# Lincoln/Haney Engineering Associates, Inc.

Re: Review of structural impact from increasing wall openings

SHEET 500

FLOOR PLAN UNIT SIX

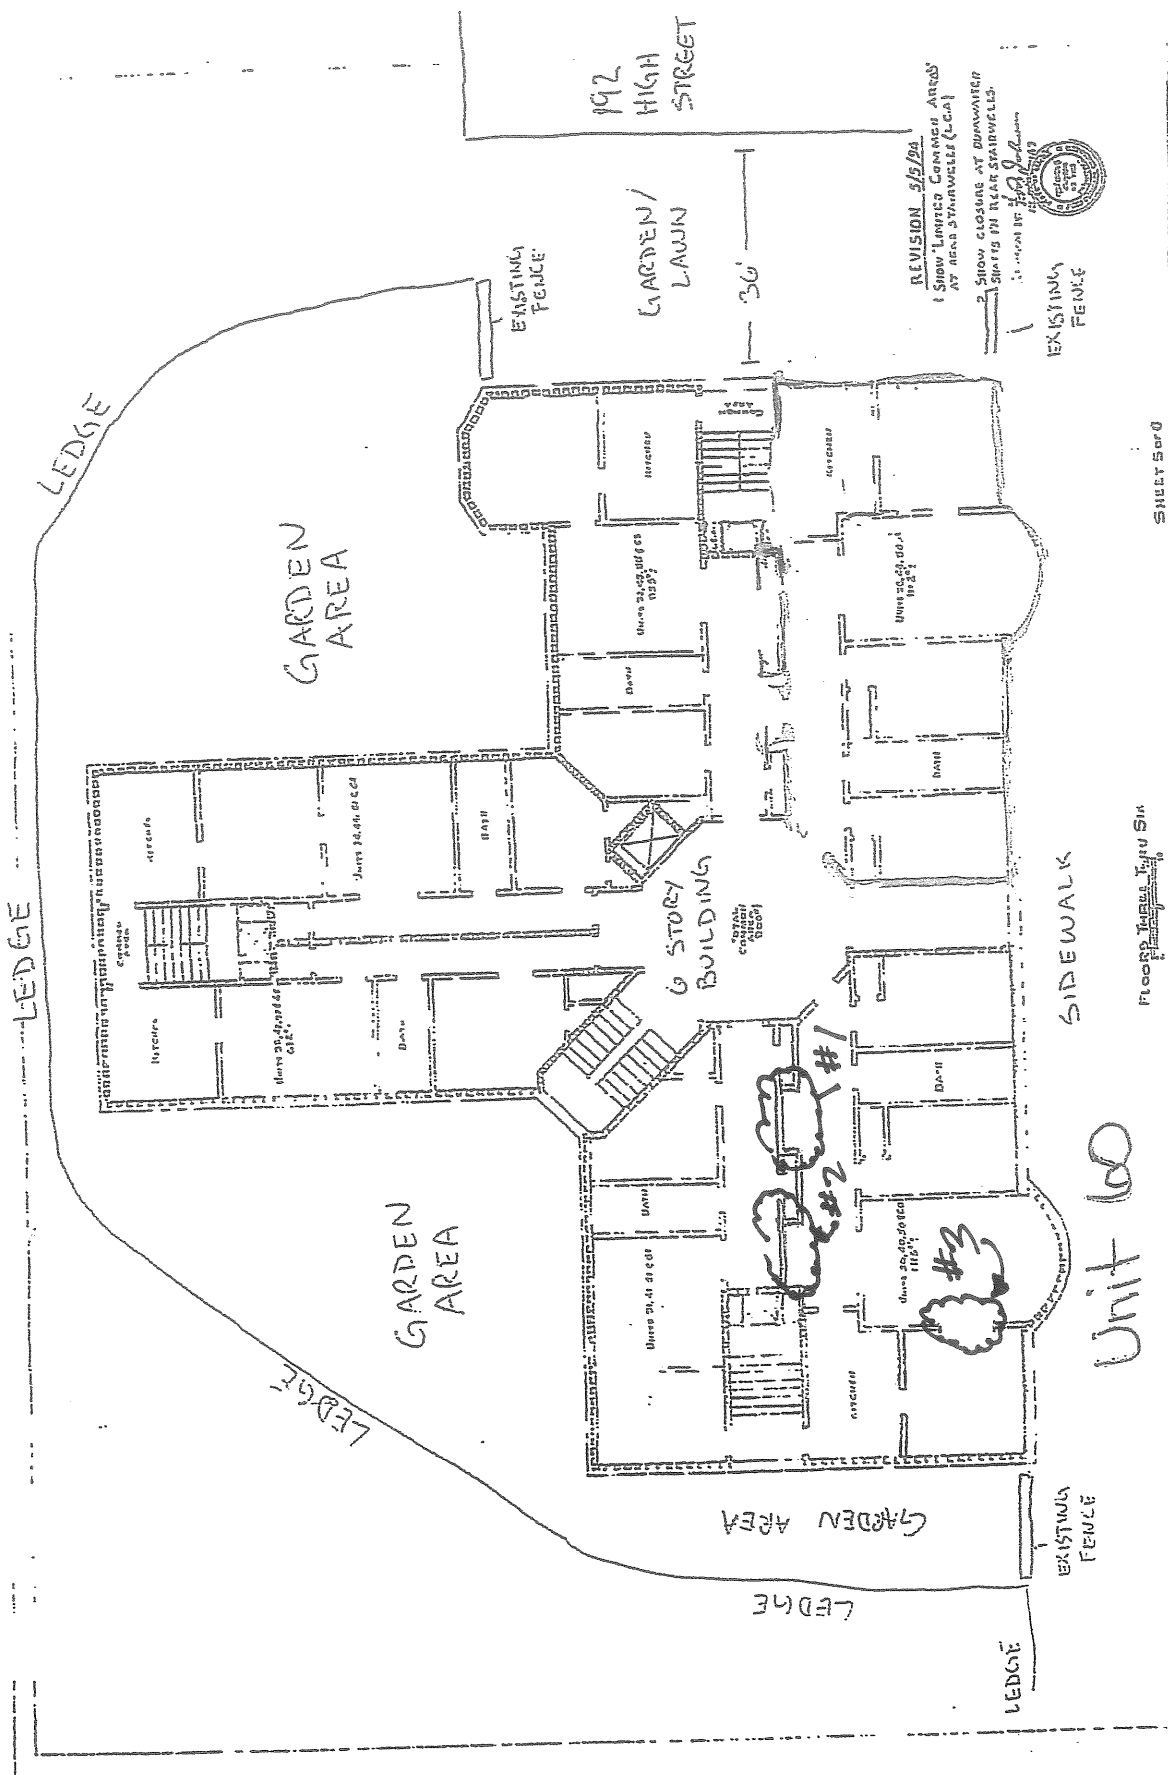
As requested, I have reviewed the layout of load-bearing walls at your condominium in order to assess the impact of the widening of openings in walls that is planned for renovations. Attached is a sketch of the planned renovations with the new, widened openings identified as #1, #2, and #3.

Regarding the planned renovations, the load-bearing portion of the wall that contains openings #1 and #2 does not extend to opening #1. It does extend about 3' into the widened 6' opening #2. However, since the joists are continuous over the top of the wall without splices and the spans on either side of the wall are only 3'-6" and 5'-6", it is not necessary to provide temporary support for the roof construction during demolition. This assumes that the demolition and reconstruction can occur when there is not a significant snow load on the roof. I do recommend that the header utilized to span the new 6 foot opening consist of 2-2x8 members of #2 Spruce-Pine-Fir, or better. The wall that contains opening #3 is parallel with framing members and, therefore, is not load-bearing.

To summarize, I find that openings #1 and #3 do not occur in load-bearing walls. Standard details for framed openings in a non-bearing partition may be utilized. At opening #2, approximately 1/2 of the opening is within a load-bearing portion of the wall. But because the rafters above are continuous over the wall with short spans on both sides of the wall, shoring of the roof construction is not required during construction unless that construction is delayed to

coincide with a period of heavy snow accumulation. Over opening #2, a lintel should be used with a minimum size of 2-2x8 of lumber #2 grade and Spruce-Pine-Fir species graded under NLGA rules, or better.
